PRODUCT UPDATE

Number: 152
By: Applications Engineering Dept.
Date: May 26, 2015

New Split Mid-Pieces:1S, 1E, and 1V Series Triaxial

1S

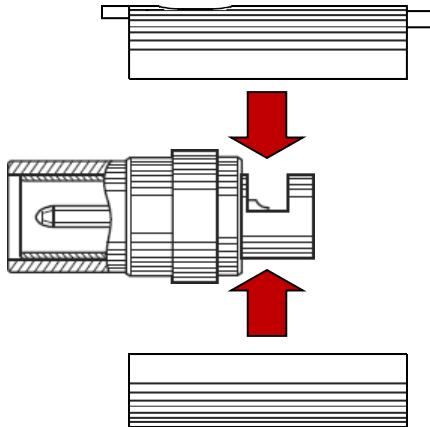
Details of Product Change: Triaxial inserts previously used a single insert carrier, while the new inserts will use a split insert carrier. Both the legacy and new designs are shown below.

Triaxial inserts in the 1S, 1E, and 1V Series will now use a split insert carrier in cable mounted models like those used in the B and K Series.
